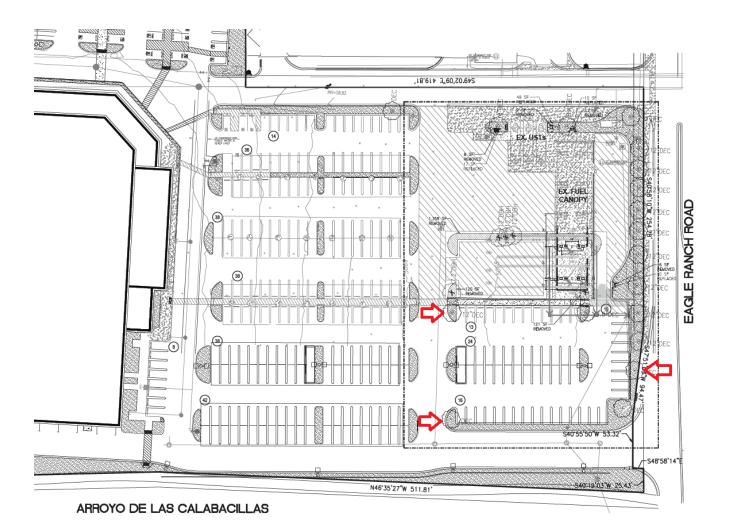
1. Remove & replace trees marked in red on the site plan (attached). these trees are in very poor health and have structural issues. The tree along eagle ranch is probably in the worst shape of all, and planted too close to the wall.

- 2. Bring the irrigation along eagle ranch Road up to city spec 3 bubblers per tree. All trees along Eagle Ranch Road need to have irrigation installed. Drip irrigation is not allowed within the Right of Way area per the IDO:

- 3. Trim trees along Eagle Ranch Road per IDO specifications. Some of the trees are overhanging into the road which is not acceptable and it is the owner's responsibility to maintain these so they are not a hazard. Below ae the relevant IDO codes for your reference:

- 5-6(C)(9)(c) Where landscaping is installed in the public right-of-way, the applicant shall install an adequate irrigation system that meets the minimum technical requirements In Article 6-6 of ROA 1994 (Trees, Vegetation and Landscaping) and the DPM, with a separate meter for the landscape area in the public right-of-way, or a separate valve(s) at the property line allowing isolation of the irrigation to the landscape within the public right-of-way. Drip irrigation systems and artificial turf shall not be allowed within the public right-of-way.

- 5-6(C)(9)(a) All planting of vegetated material or installation of any landscaping, buffering, or screening material in the public right-ofway shall require the prior approval of the City. The property owner shall be responsible for the maintenance, repairs, or liability for all the landscaping placed in or over the public right-ofway.

• 5-6(C)(9)(b) Any trees that overhang a public sidewalk or Major Public Open Space shall be trimmed to maintain an 8-foot clearance over the sidewalk. Any trees that overhang a public street shall be trimmed to maintain a 9-foot clearance over the street surface.
